Subject: Collin County Healthcare Facility, Parking Garage, and Medical Examiners
Revised Request for Change (PCO) No. 032; ASI #3 Medium Voltage Scope of Work

Issue No. 032 - ASI #3 Medium Voltage Scope of Work

Re: Collin County Medical Campus
Request for Proposal – Credit MV Transformer
GME Proposal X907
GME Project #GME-24-009

COLLIN COUNTY HEALTHCARE, PARKING GARAGE, & MEDICAL EXAM. FACILITIES

SD-E5.01

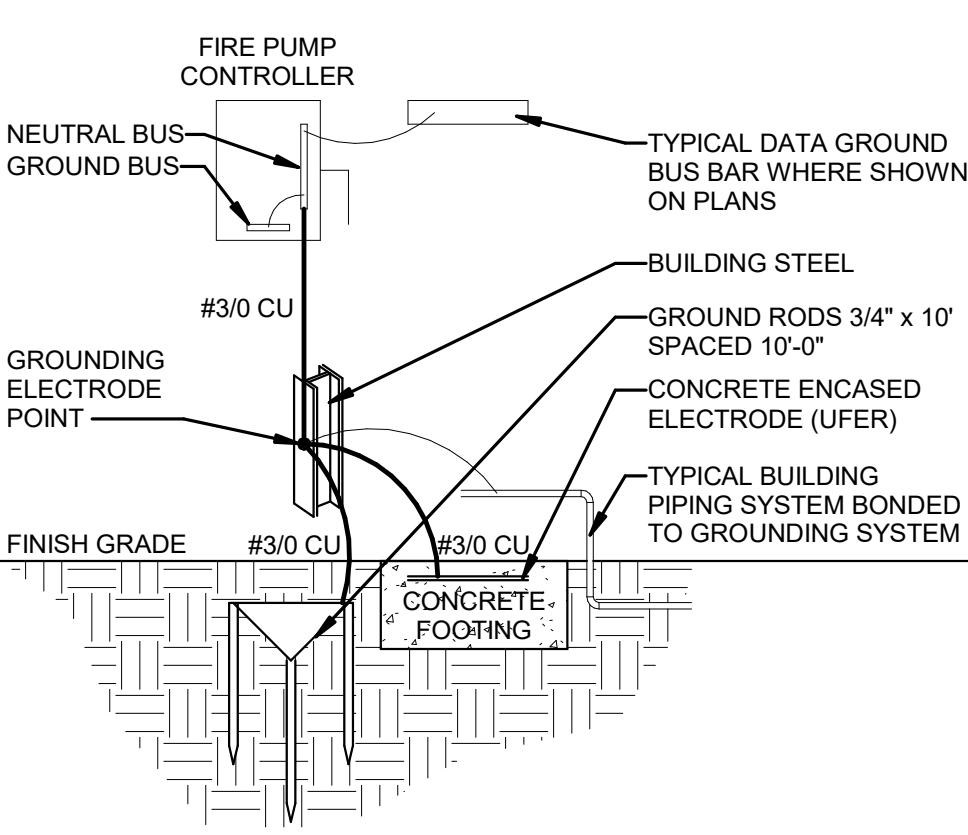
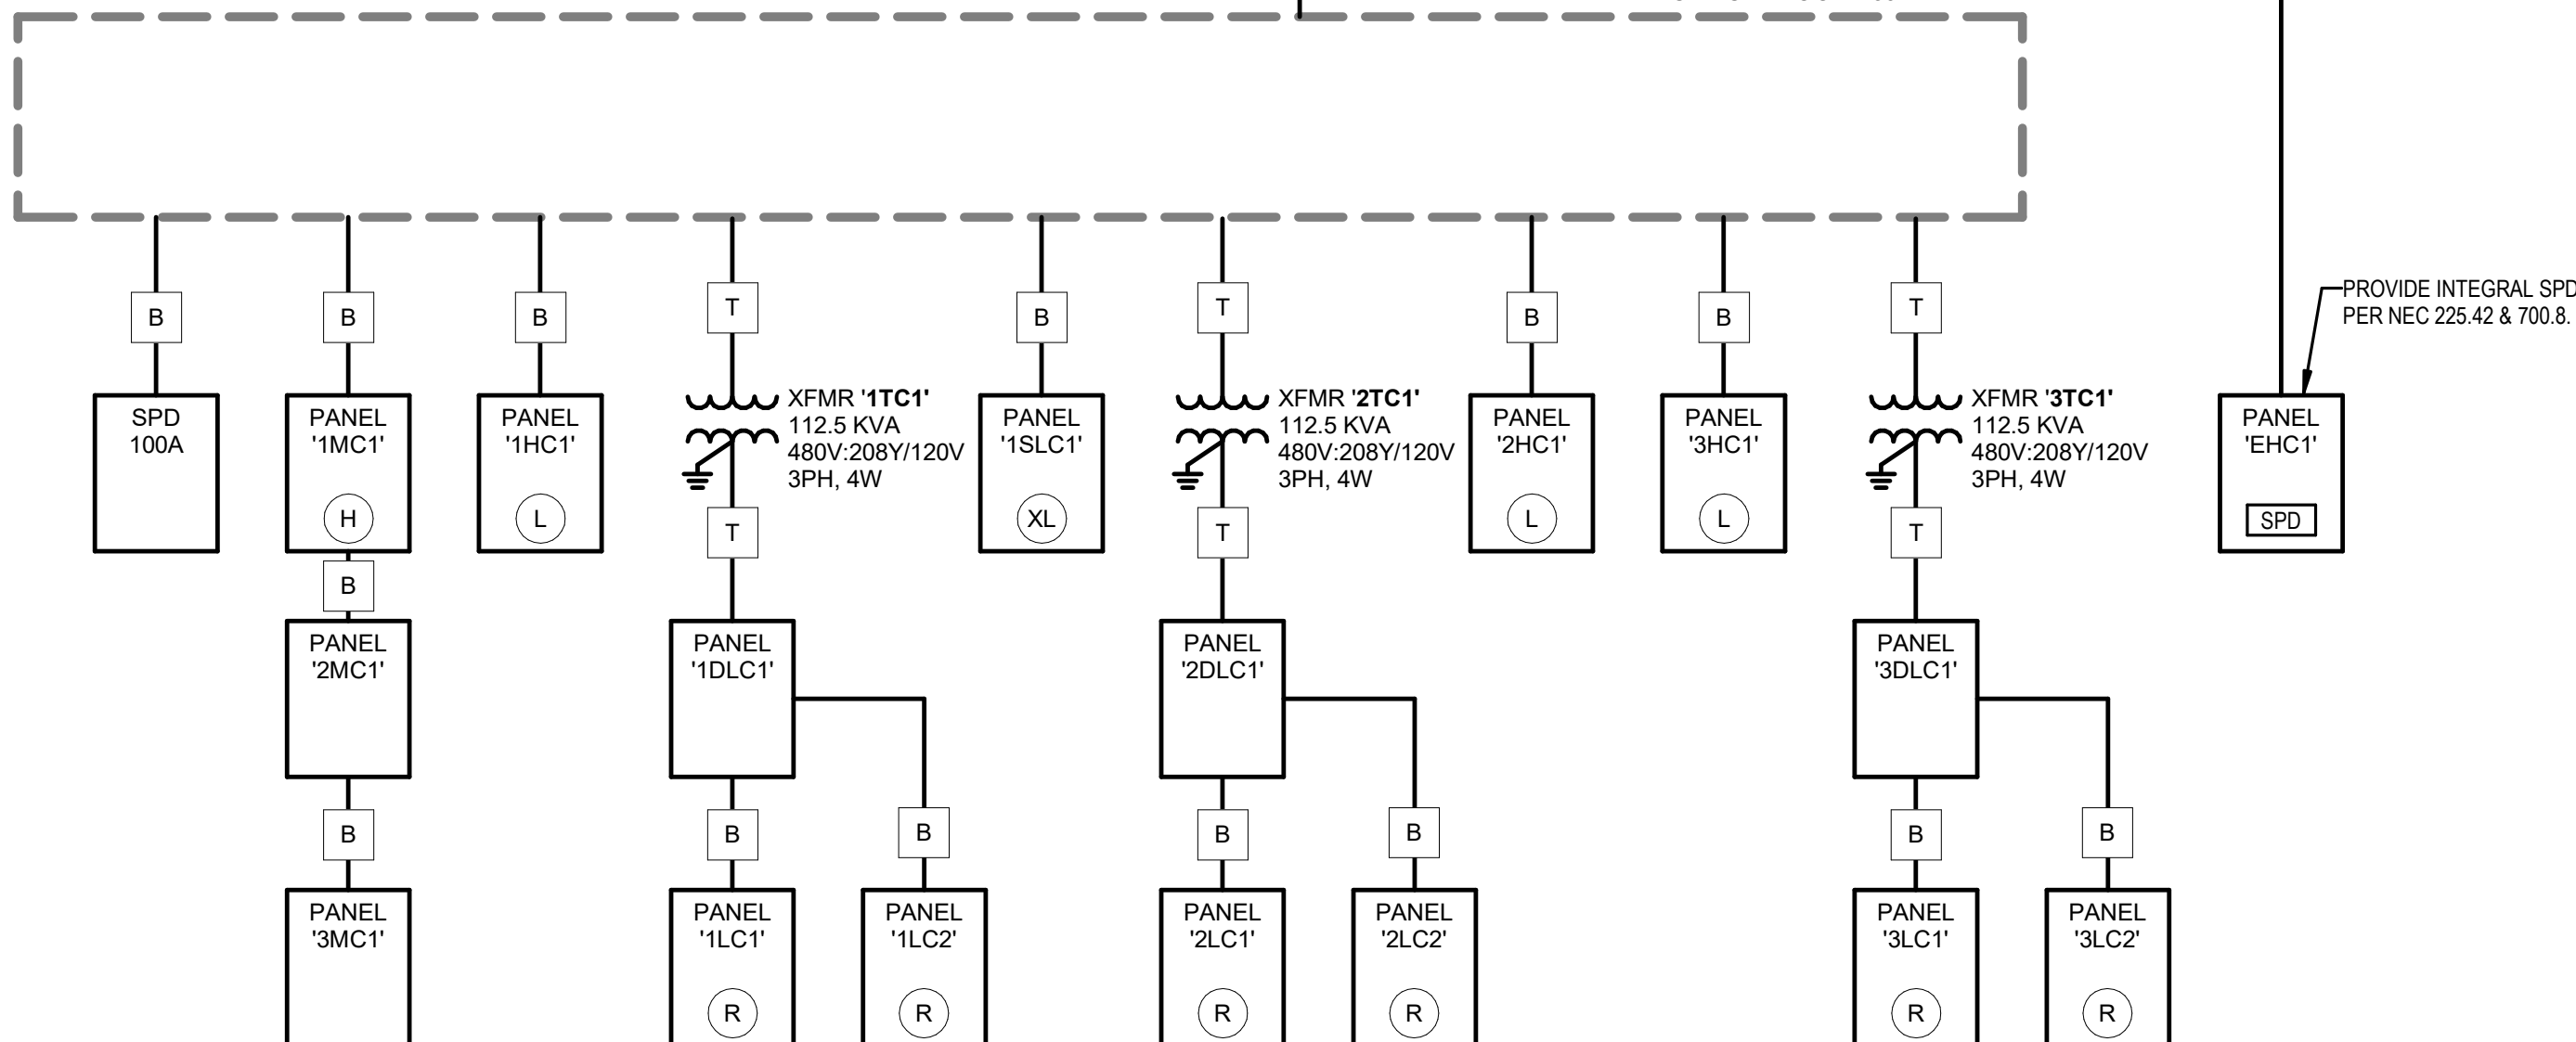
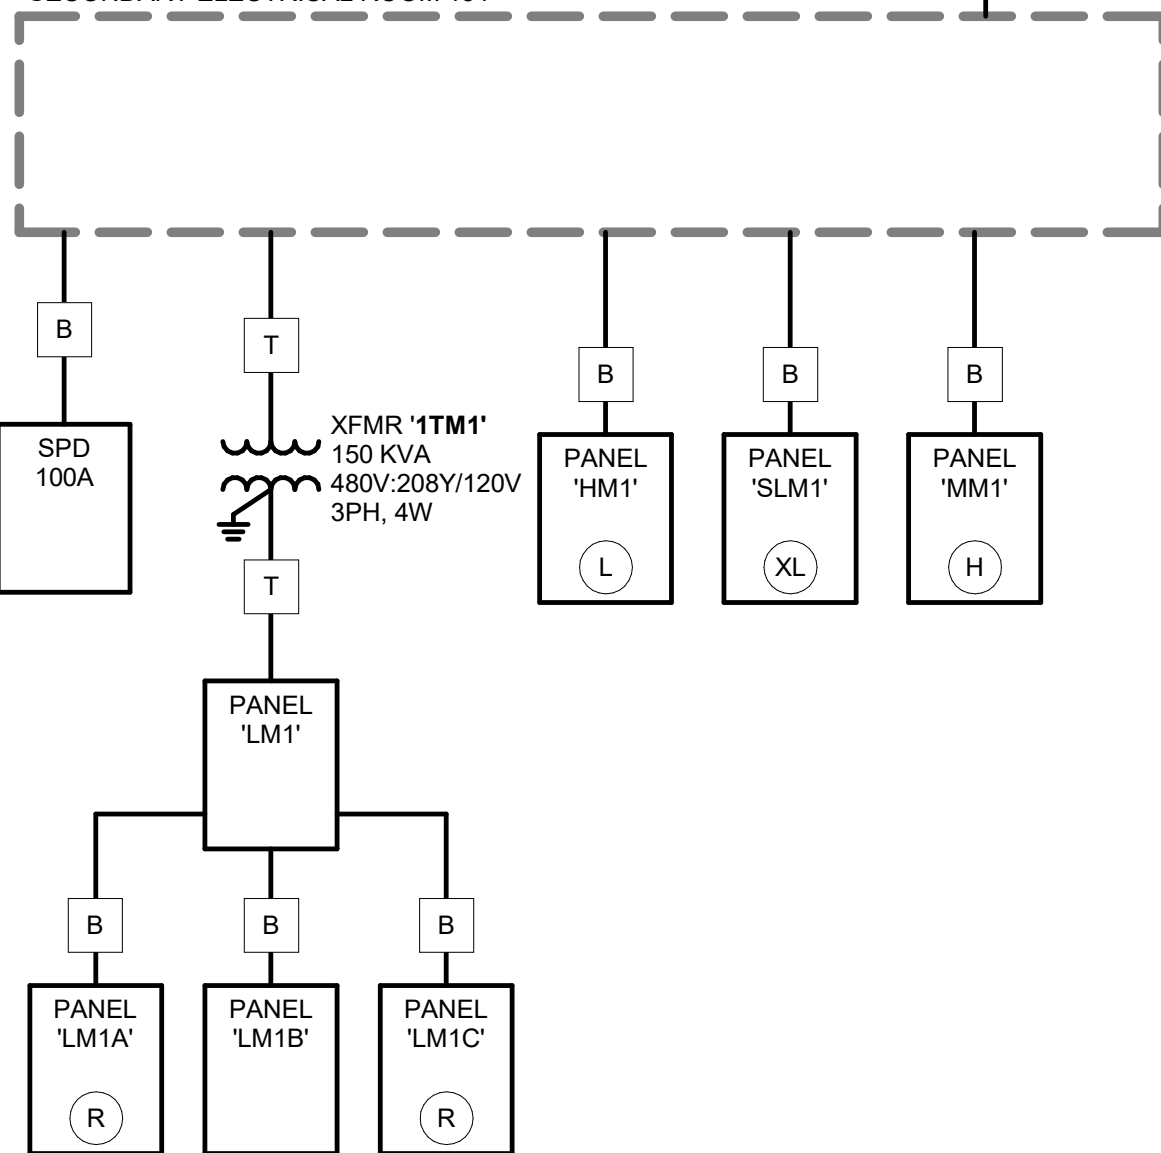
- **Per ASI #3 drawing revisions.**
- **Site Development**
 - Credit back for MV transfer and terminations.
 - Credit back for setting MV transformer.
 - Credit back for MV transfer ground loop.
 - Credit back for MV wire terminations.
 - Credit back for conduits from ATSS to DSS.
 - Per county direction this pricing PCO is being broken out from PCO #010 ASI #3 drawings revisions.
- **This includes us keeping the grounding in our scope of work as Oncor is not expected to complete that work.**
- ***This PCO will be a deduct back to the contract in the amount of \$-128,265.***

1. SD- E100- Credit for MV Transformer and terminations, Setting MV Transformer, MV transformer ground loop, MV Wire and terminations, Conduits from ATSS to DSS.

- 1) LABOR AND MATERIALS FOR INSTALLING ELBOW KITS FOR MV TERMINATIONS. THIS IS AT LEAST \$3,000-\$4,000 PER KIT. **Got estimate for MV connections**
- 2) THIRTY TWO (32) TERMINATIONS ON THE SECONDARY SIDE OF THE TRANSFORMER WHICH ONCOR IS NOW GOING TO MAKE. (24) FOR 2000A FEED TO MAIN ATSS. AND FOUR (4) FOR EACH FIRE PUMP. **Credit the (32) terms can be given back if Oncor is terminating, Lugs are still provided by GME.**

- 3) TIME AND MATERIAL FOR MEDIUM VOLTAGE GROUNDING YOU NO LONGER NEED TO DO FOR THE MV SWITCHGEAR. REFER TO DETAIL 5/SD-E0.11. **There is no note 5 grounding for MV switchgear, it is existing no grounding was in takeoff. The MV switch would already have grounding.**

- 4) TIME AND MATERIAL FOR MEDIUM VOLTAGE GROUNDING YOU NO LONGER NEED TO DO FOR THE MV XFMR. THIS INCLUDES GROUND RODS, GROUND LOOP, ETC AS STATED BY DETAIL 6/SD-E0.11. **Credit (4) 3/4x 10' grd rod 50' bare 2/0**
